Location of Construction: 706 Brighton Ave		Owner: Dvilinsky, Norman & Mary		Phone: 774-3406		Permit No: 960868	
Owner Address: SAA Pctd, ME 04102		Leasee/Buyer's Name:		Phone:		BusinessName:	
Contractor Name: S.F. Rankin		Address:		Phone:		<div style="border: 2px solid black; padding: 5px; text-align: center;"> PERMIT ISSUED Permit Issued: SEP - 4 1996 CITY OF PORTLAND </div>	
Past Use: 1-fam		Proposed Use: Same		COST OF WORK: \$ 6,500.00 PERMIT FEE: \$ 55.00			
Proposed Project Description: Construct Garage 18 x 24 - Detached		FIRE DEPT. <input type="checkbox"/> Approved <input type="checkbox"/> Denied		INSPECTION: Use Group: U Type: 5		Zone: CBL: 224A-A-016	
		Signature:		Signature:		Zoning Approval: Special Zone or Reviews: <input type="checkbox"/> Shoreland <input type="checkbox"/> Wetland <input type="checkbox"/> Flood Zone <input type="checkbox"/> Subdivision <input type="checkbox"/> Site Plan maj <input type="checkbox"/> minor <input type="checkbox"/> mm <input type="checkbox"/>

BUILDING PERMIT REPORT

DATE: 4/SEPT/96 ADDRESS: 706 Brighton Ave
REASON FOR PERMIT: To Construct 18x24 detached garage
BUILDING OWNER: Dralinsky's
CONTRACTOR: SIP. BANKI
PERMIT APPLICANT: owner ~~

706 Brighton Ave. - 224A-A-16

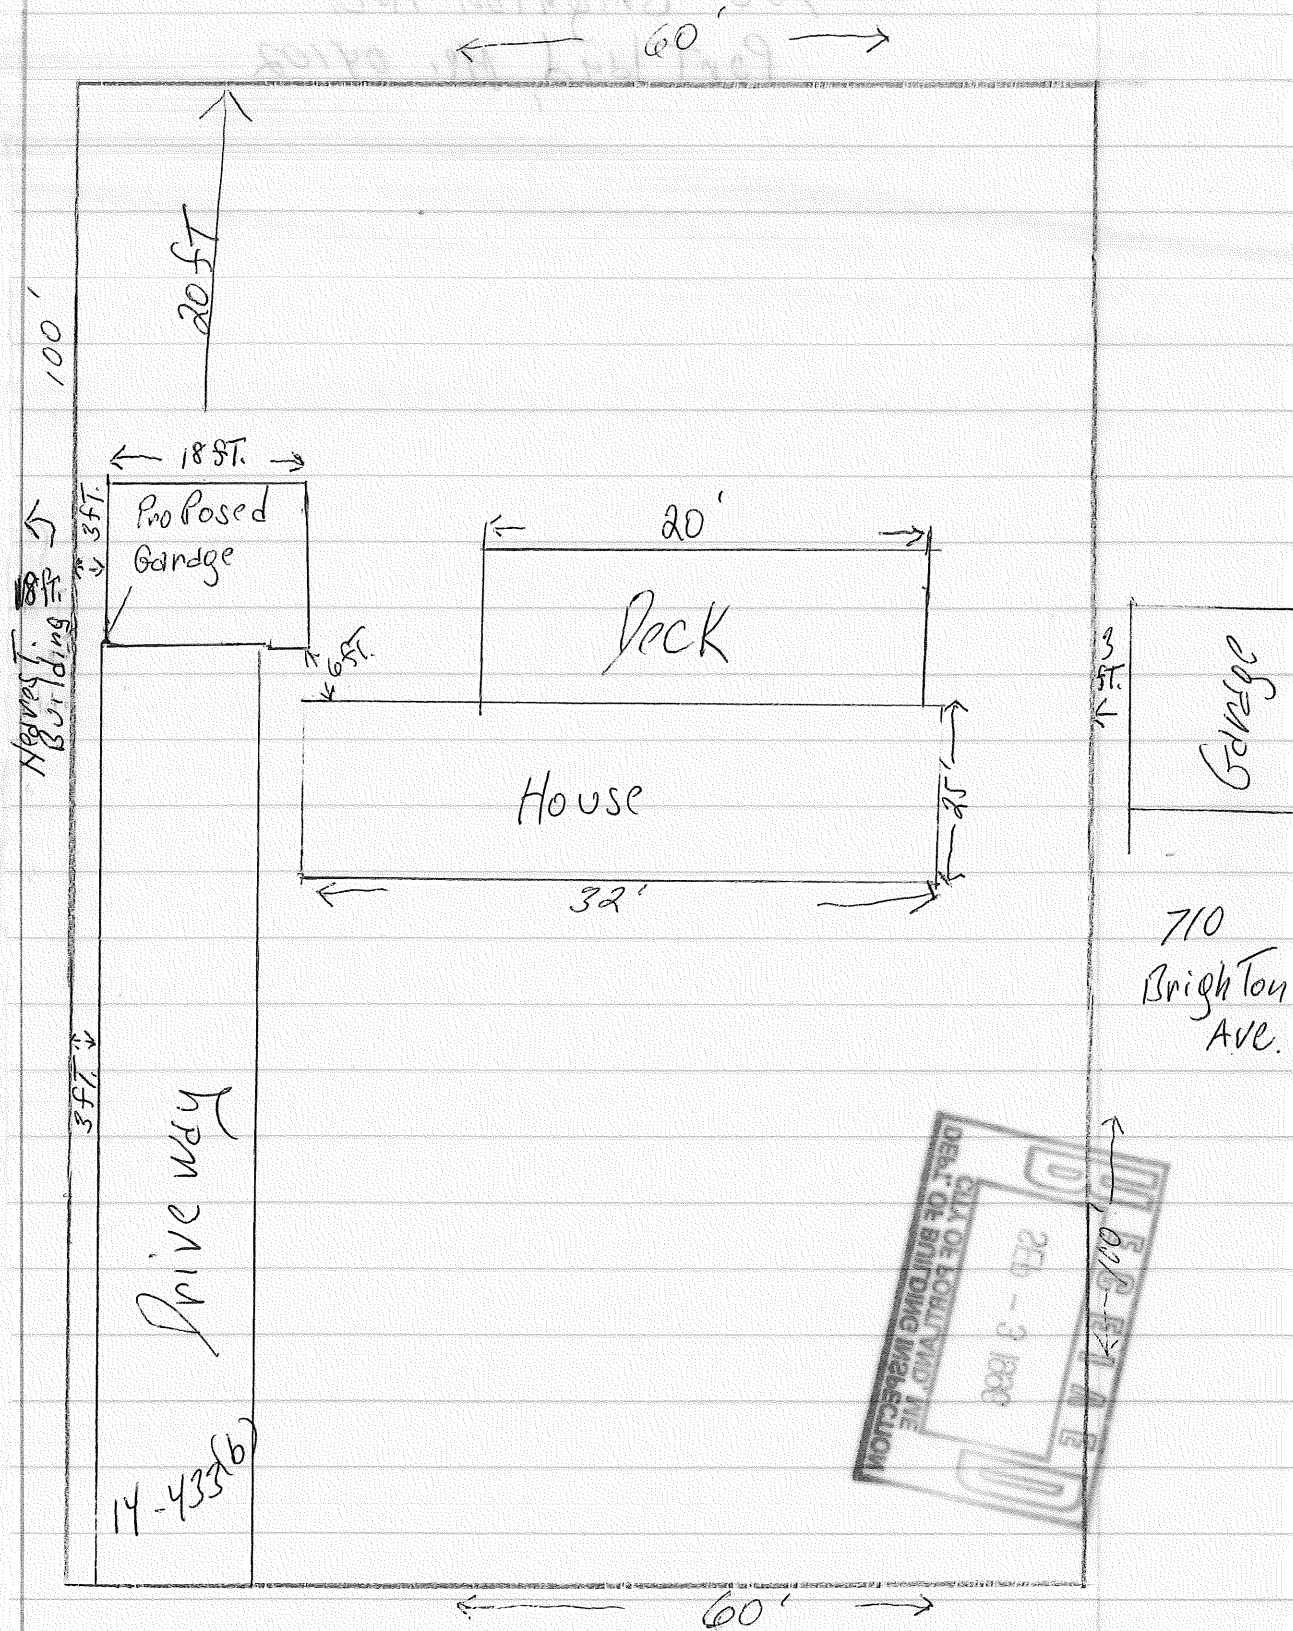
Front Yard - 25' req - 25' + shown

Rear Yard - 25' req - 20' shown -> using Section A-433 (b)

Side Yard - 0' req - 3' shown -> Allows AS close AS 20' from rear

Projections - Again using section A-433 (b), Allows AS close AS 3' from side

(New) 18 x 24 = 432

25 x 32 = 800

14 x 19 = 266

removed x 10 = 50
1498 sq ft
